**CITY OF ISANTI  
PLANNING COMMISSION MEETING  
TUESDAY, August 17, 2021  
Immediately following the 7:30pm Budget Work Session  
CITY HALL**

SUBJECT: Site Plan Review for a proposed Dental Clinic and Commercial Tenant building located at 401 Cherrywood St NE (Isanti Dental)

**Date:** July 29, 2021  
**To:** Sheila Sellman, Community Development Director  
**From:** Jason W Cook, P.E.  
City Engineer  
**Subject:** Isanti Dental Clinic - Plan Set - Engineering Review  
City of Isanti, MN  
Project No.: 0R1.123130

Isanti Fire has reviewed the proposed Isanti Dental Clinic at 401 Cherrywood St NE, in the City of Isanti. Listed below are concerns regarding fire safety, as well as applicable language from the 2015 MN State Fire Code.

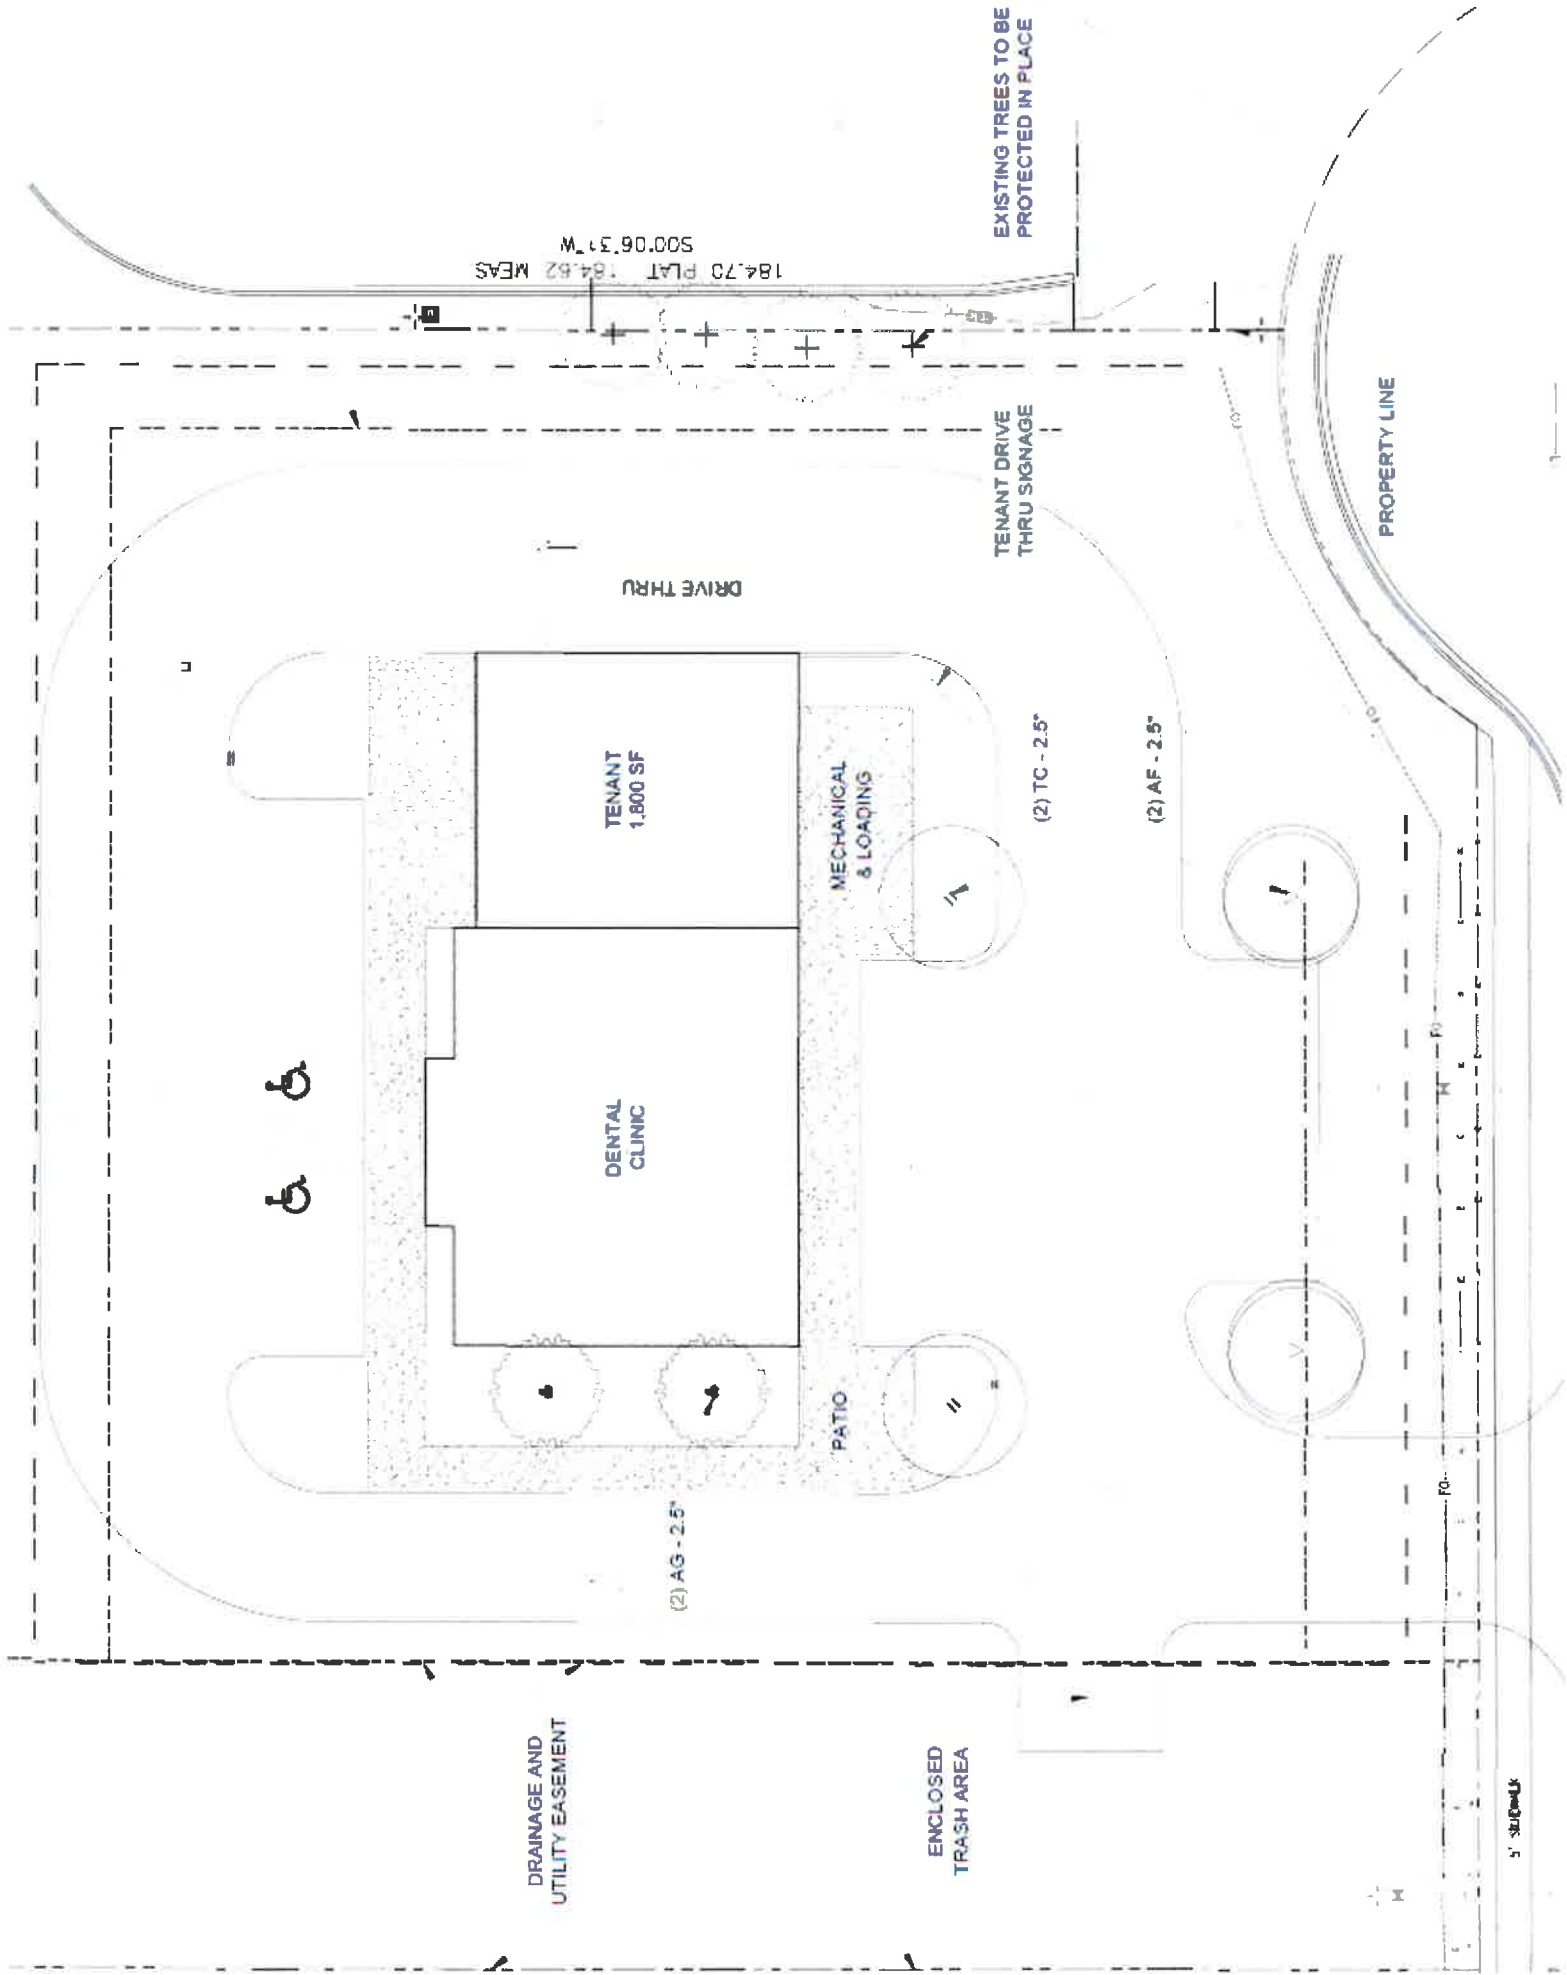
*The site features 90-degree parking stalls and will have two-way traffic for the parking area on the south of the proposed building. The drive thru lane and thru traffic lane will begin the one-way vehicle circulation. Stall dimensions are shown as 9 feet in width and 19 feet in length and follow this requirement. The drive aisle widths around both parking areas and drive thru lanes are proposed for at least 26 feet and meet the requirement for both one-way and two-way vehicle circulation. The drive aisle reduces from two lanes to one lane proposed at 18 feet around the west side of the building. The Fire Chief's memo mentions that the proposed width of 18 feet is not accommodating to fire apparatus operations and should be widened to at least 20 feet on the west side of the building.*

*The trash enclosure is proposed to be located southwest of the building near the drive aisle lane. The trash enclosure appears to be located within the drainage and utility easement, and will need to be relocated on the site plans. The trash enclosure on the site plan shows that it will be*

*18 ft in width and 20 ft in length. The appearance and materials of the trash enclosure have not been shown on submitted architectural plans, the enclosure shall follow the regulations set in Section 14, Subdivision 3 of the City's Zoning Ordinances and shall be enclosed. The trash enclosure shall also be illuminated for the safety of employees. The landscape plan shows bushes surrounding the trash enclosure for shielding from surrounding properties, once the enclosure is relocated it will also need to have landscaping shielding.*

An outdoor patio is proposed on the southwest side of the building near the south parking stalls. It is unclear if the patio area will include tables and chairs, if that is the intent of the patio, they should be shown on the site plans where they will be located. The outdoor seating area shall follow all requirements listed in Section 13 Subdivision 14 of the City Zoning Ordinances.

1. Location of freestanding light poles and exterior building lighting shall be shown on site plans and approved by staff
2. The outdoor patio area shall be shown on site plans with configurations of tables and chairs if they will be used on site and follow all requirements listed in Section 13 Subdivision 14 of the City Zoning Ordinances
3. A Conditional Use Permit is required for a Drive Thru window on the commercial tenant side of the building
4. Trash enclosure architectural plans shall be submitted for staff review.
5. Trash enclosure shall be relocated on site plans out of the drainage and utility easement.
6. A photometrics plan shall be submitted to review lighting types and foot candle readings

7. All signs shall require a sign permit when applicable to determine dimensions and locations and shall follow Section 16 of the City's Zoning Ordinances
8. Applicant shall apply for all permits associated with the building including but not limited to a building permit, mechanical permit, plumbing permit, electrical permit, and sewer and water hookup.
9. Drive lane on the west side of the building shall be increased to 20 feet.
10. All conditions/comments listed in the City Engineer's memo dated 7/29/2021 shall be addressed
